UNITED STATES PATENT AND TRADEMARK OFFICE

APPLICATION NO.	FILING DATE	FIRST NAMED INVENTOR	ATTORNEY DOCKET NO.	CONFIRMATION NO.
10/710,254	06/29/2004	Carlo Gemme	22106-00067-US1	4253
30678	7590	09/29/2005	EXAMINER	
CONNOLLY BOVE LODGE & HUTZ LLP SUITE 800 1990 M STREET NW WASHINGTON, DC 20036-3425			BAUER, SCOTT ALLEN	
			ART UNIT	PAPER NUMBER
			2836

Office Action Summary	Application No.	Applicant(s)	
	10/710,254	GEMME ET AL.	
	Examiner	Art Unit	
	Scott Bauer	2836

DETAILED ACTION

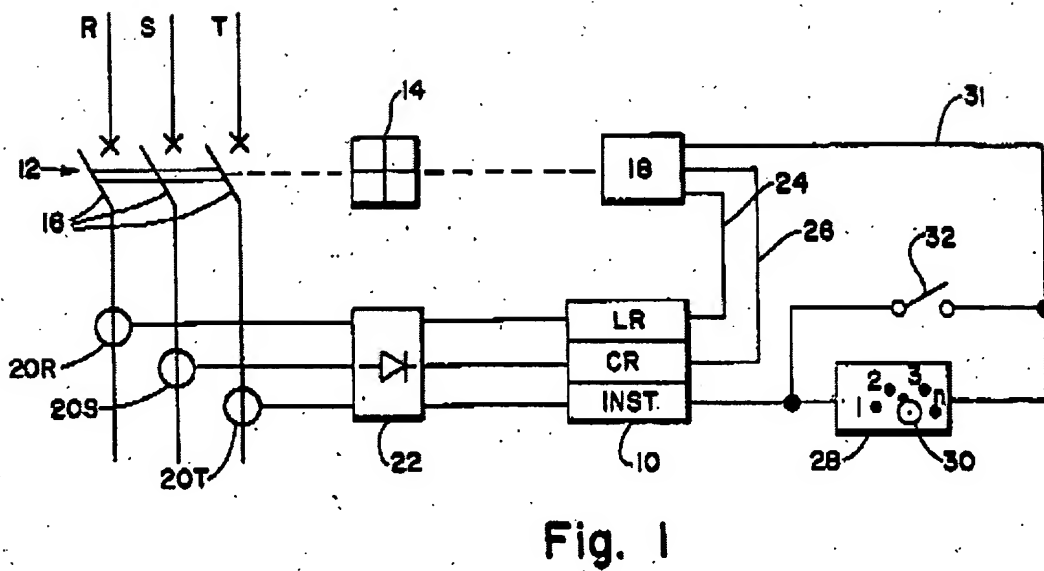
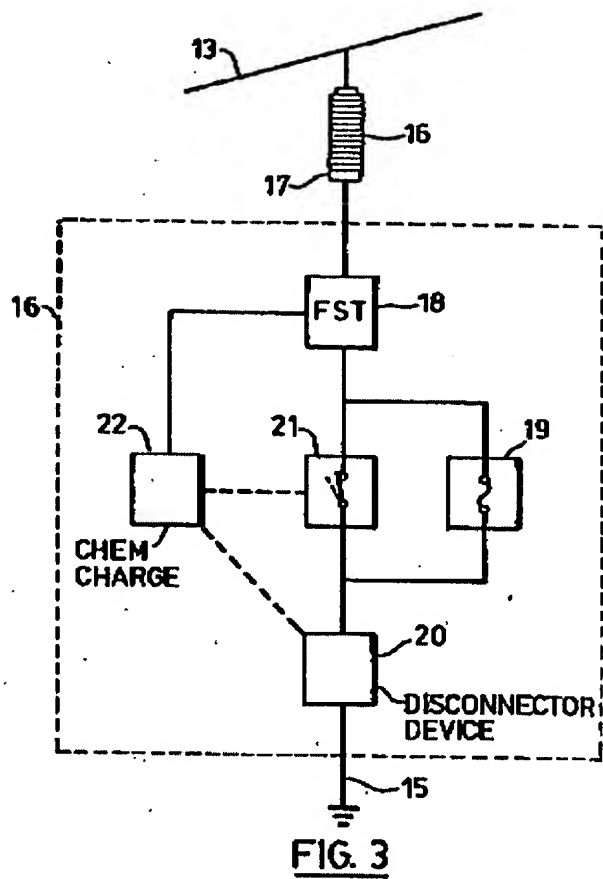
2. Figure 1 should be designated by a legend such as --Prior Art-- because only that which is old is illustrated. See MPEP § 608.02(g). Corrected drawings in compliance with 37 CFR 1.121(d) are required in reply to the Office action to avoid abandonment of the application. The replacement sheet(s) should be labeled "Replacement Sheet" in the page header (as per 37 CFR 1.84(c)) so as not to obstruct
